SUBSURFACE WASTEWATER DISPOSAL SYSTEM VARIANCE REQUEST

GENERAL INFORMATION		Town of <u>AUGUSTA</u>
Property Owner's Name:	<u>WELLS, LOREN</u>	Tel. No.: <u>458-0035</u>
System's Location:	<u>238 CHURCH HILL ROAD</u>	
Property Owner's Address:	<u>40 WOODY HAYWOOD</u>	Zip Code _____
e-mail address:	<u>238 CHURCH HILL ROAD, AUGUSTA, ME 04330</u>

Subject: Approval, Replacement System Variance Request, Lorren Wells Property, C/O Woody Hayood Property, 238 Church Hill Road, Augusta, Maine. Mailing Address Owner/Applicant: SAME.

SITE PLAN

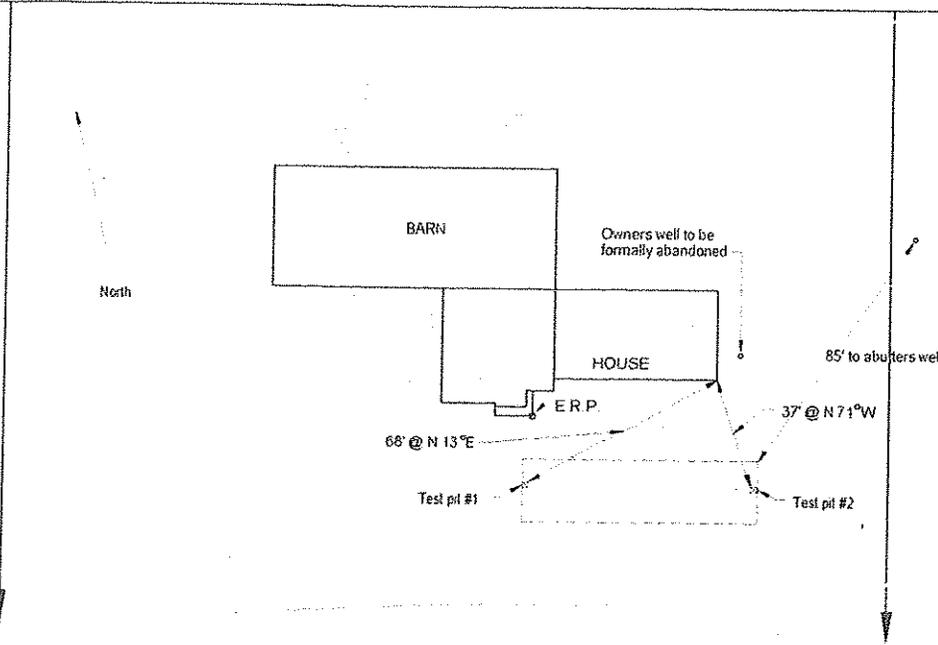
The variance request that is not within the LPI's authority is 0 inches to bedrock.

The variance request that is within the LPI's authority is from the disposal field to a potable water supply of 85 feet.

The variance request has been submitted because topography and existing development limit the potential of the system location and the system design prepared by Stephen Robins, SE #301 on 09-21-2015 is otherwise found to be in compliance with the Maine Subsurface Wastewater Disposal Rules.

The system is to be installed in accordance with the submitted and approved system design. Should alterations to the design be required at the time of construction, the site evaluator is to be notified prior to making any changes.

The contractor is to scarify the soils under the fill extensions to create a transitional zone more compatible with the disposal field area.
